RAILROAD COMMISSION OF TEXAS

OIL AND GAS DOCKET NO. 08-0282332

THE APPLICATION OF TREY RESOURCES, INC., PURSUANT TO STATEWIDE RULE 46 FOR A PERMIT TO INJECT FLUID INTO A RESERVOIR PRODUCTIVE OF OIL OR GAS, SAVAGE LEASE, WELL NOS. 1 AND 9, SHAFTER LAKE (SAN ANDRES) FIELD, ANDREWS COUNTY, TEXAS.

EXAMINERS' REPORT AND PROPOSAL FOR DECISION**STATEMENT OF THE CASE**

Exhibit No. 5
O & G Docket No. 08-0282332
Date: October 23, 2013
Trey Resources, Inc.

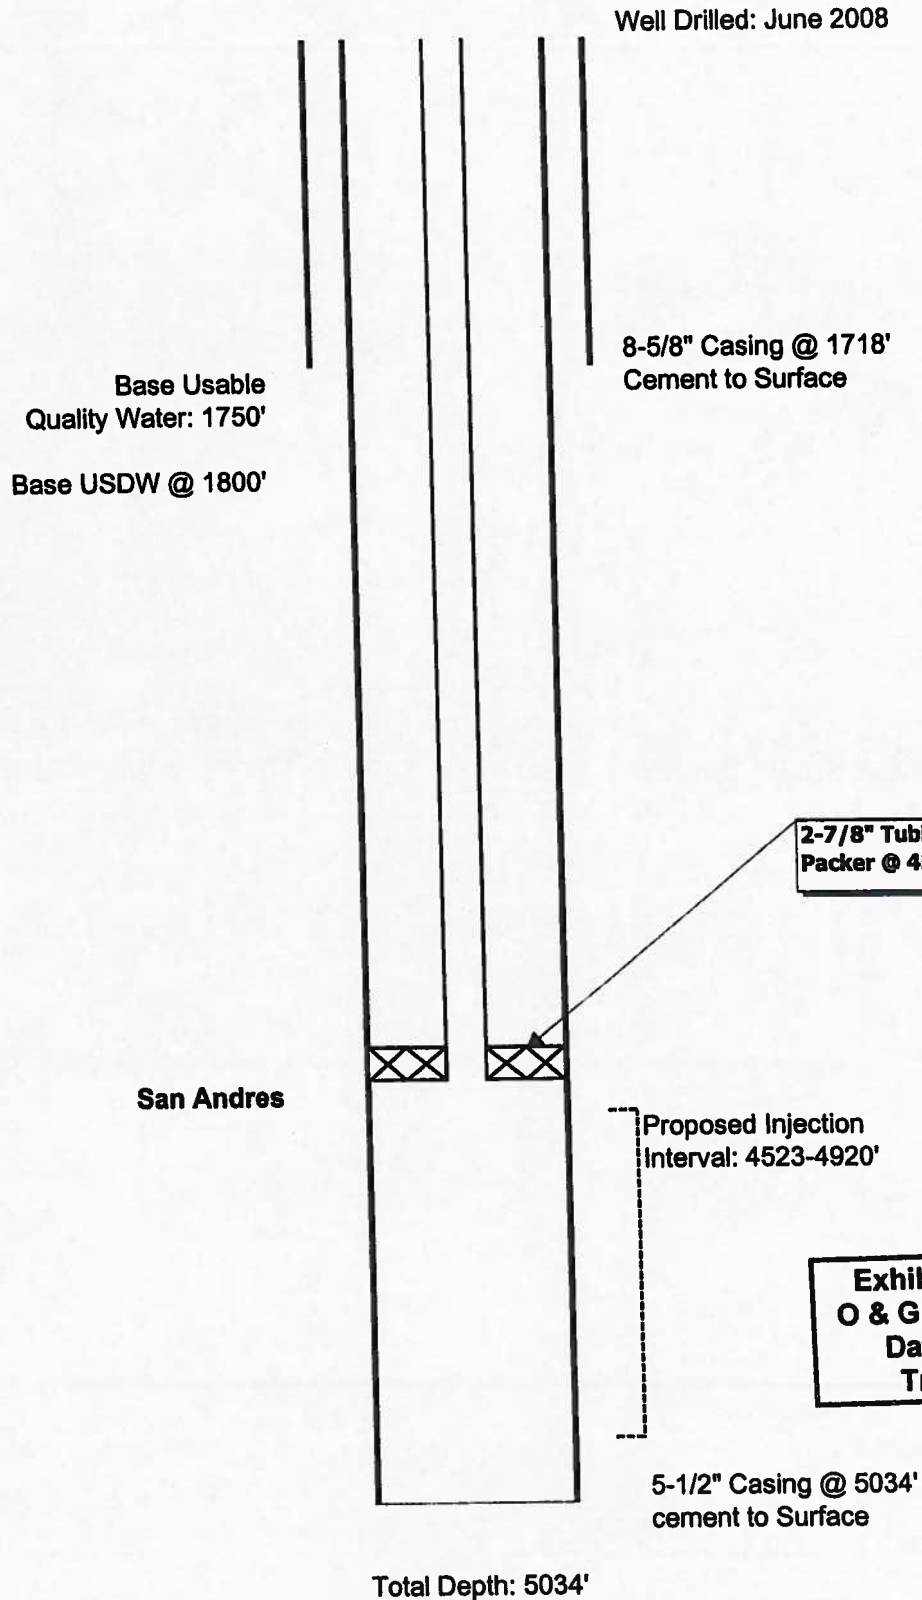
To re-complete the Savage No. 9 for injection, Trey proposes the following (wellbore diagram attached, Trey Exhibit No. 5):

- An injection interval from 4,523 feet to 4,920 feet
- 2 7/8-inch tubing with packer set at 4,500 feet
- A maximum daily injection rate of 2,500 barrels of produced salt water
- A maximum surface injection pressure of 2,000 psig

- e. An injection interval from 4,728 feet to 4,920 feet.
 - f. 2 7/8-inch tubing with packer set at 4,700 feet.
9. Well No. 9 will be recompleted as an injection well as follows:

- a. 8 5/8-inch surface casing set to 1,718 feet and cement circulated to surface (note the W-15 for this casing string indicates 1,760 feet of casing was set).

- b. 5 1/2-inch casing set to 5,034 feet and cemented circulated to surface.
 - c. An injection interval from 4,523 feet to 4,920 feet.
 - d. 2 7/8-inch tubing with packer set at 4,500 feet.
